Form 3160-5
(June 2019)

SUNDRY NOTICES AND REPORTS ON WELLS
Do not use this form for proposals to drill or to re-enter an abandoned well. Use Form 3160-3 (APD) for such proposals.

Ripple 32 Fed Com 726H (FKA 202H) API #: 30-025-49605

EOG respectfully requests an amendment to our approved APD for this well to reflect the following changes:

WELL LOCATION AND ACREAGE DEDICATION PLAT

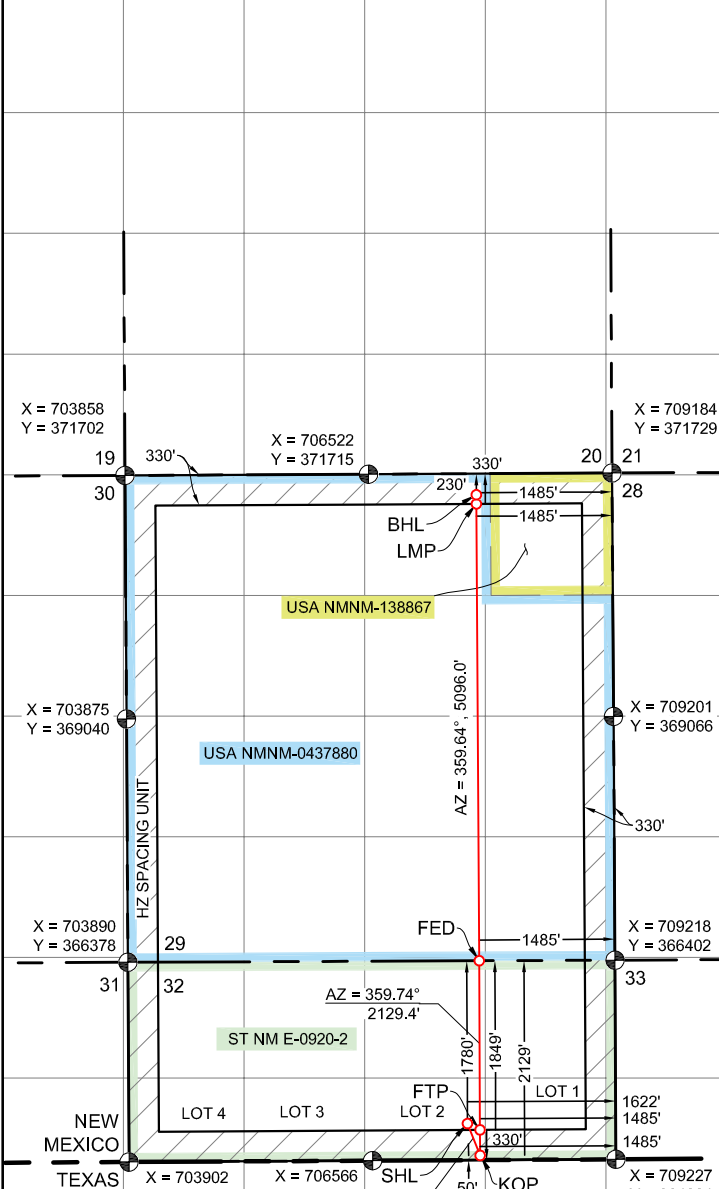
Change name from Ripple 32 Fed Com 202H to Ripple 32 Fed Com 726H.

Change SHL from T-26-S, R-31-E, Sec 32, 1764' FNL, 1347' FEL, Eddy Co., NM, to T-26-S, R-31-E, Sec 32, 1780' FNL, 1622' FEL, Eddy Co., N.M.

Change BHL from T-26-S, R-31-E, Sec 29, 1431' FNL, 1210' FEL, Eddy Co., NM, to T-26-S, R-31-E, Sec 29, 230' FNL, 1485' FEL, Eddy Co., N.M.

Update the Pool as reflected in the C-102.

UL or lot no.	Section	Township	Range	Lot Idn	Feet from the	North/South line	Feet from the	East/West line	County
2	32	26 S	31 E		1780	NORTH	1622	EAST	EDDY

UL or lot no.	Section	Township	Range	Lot Idn	Feet from the	North/South line	Feet from the	East/West line	County
B	29	26 S	31 E		230	NORTH	1485	EAST	EDDY
